Government of India - Ministry of Railways
Research Designs & Standards Organization,
LUCKNOW - 226011

**SPECIAL MAINTENANCE INSTRUCTION NO. RDSO/2007/EL/
SMI/ 0244, Rev. 'O' DATED 02.04.2007**

Provision of additional safety sling on brake levers of WAP7 & WAG9 locomotive.

**PROVISION OF SAFETY SLING FOR BRAKE LEVER
OF WAP7/WAG9 LOCOMOTIVES**

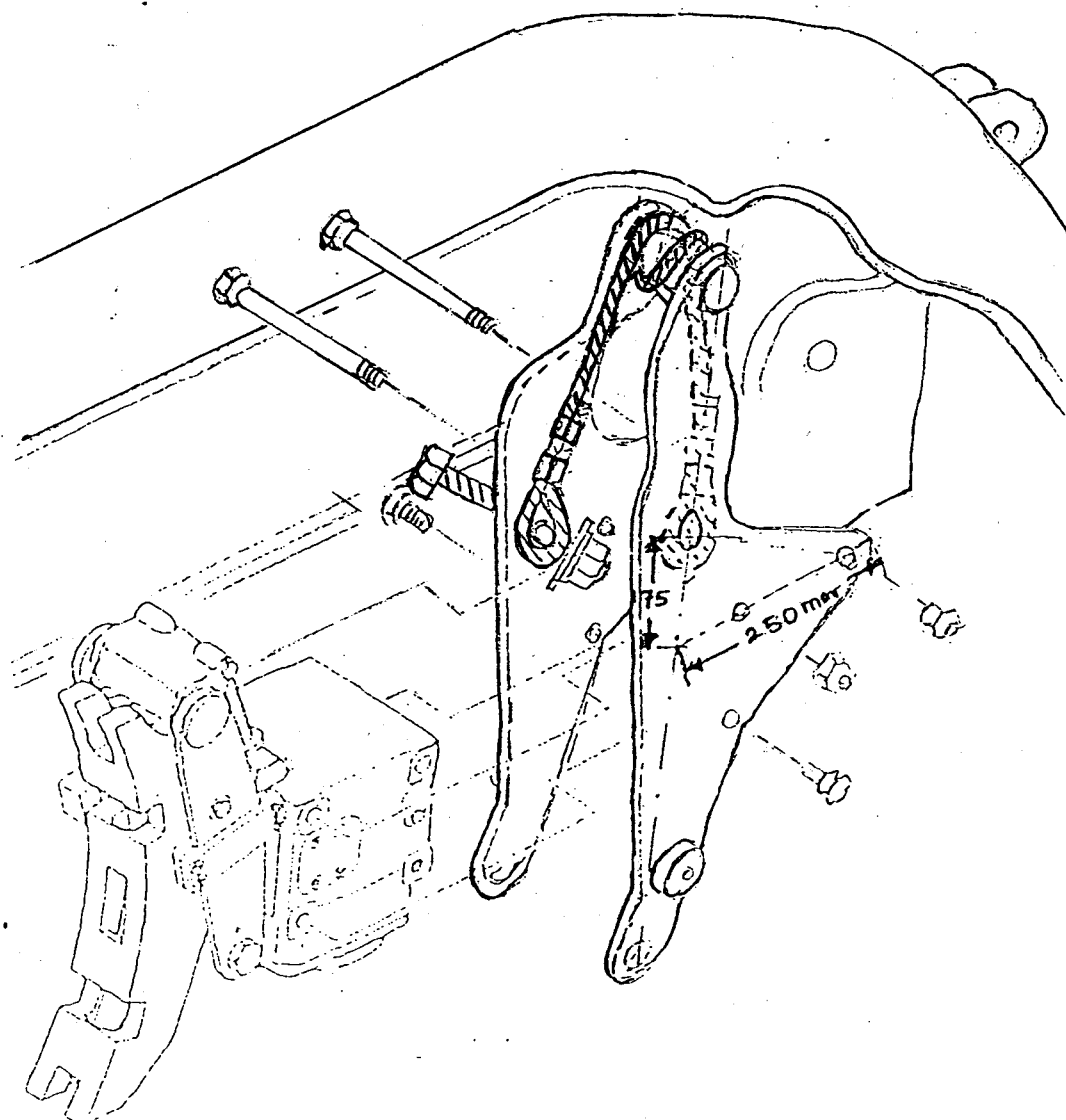
It is, therefore, decided to provide safety sling arrangement on TBUs/PBUs expeditiously as an interim measure until more appropriate design proposals are finalized. Accordingly, sheds are advised to provide sling (8mm dia, 1220 mm long) double crimped at both ends and fastened with 16x45 mm bolt with lock nut and washers by drilling hole with 17.5mm drill on both levers at location as indicated in the drawing enclosed. Special care should be taken while drilling the hole in the brake lever so that all burrs and sharp edges are removed. Slings when provided should be loose enough not to take any load in normal condition and to avoid impact load in event of breakage of the levers.

- i)** Safety sling 8mm dia as per IS 2762:1982 with double crimping at both ends as given in the enclosed drawing.
- ii)** 16x45mm bolt with nut, spring and plain washers.
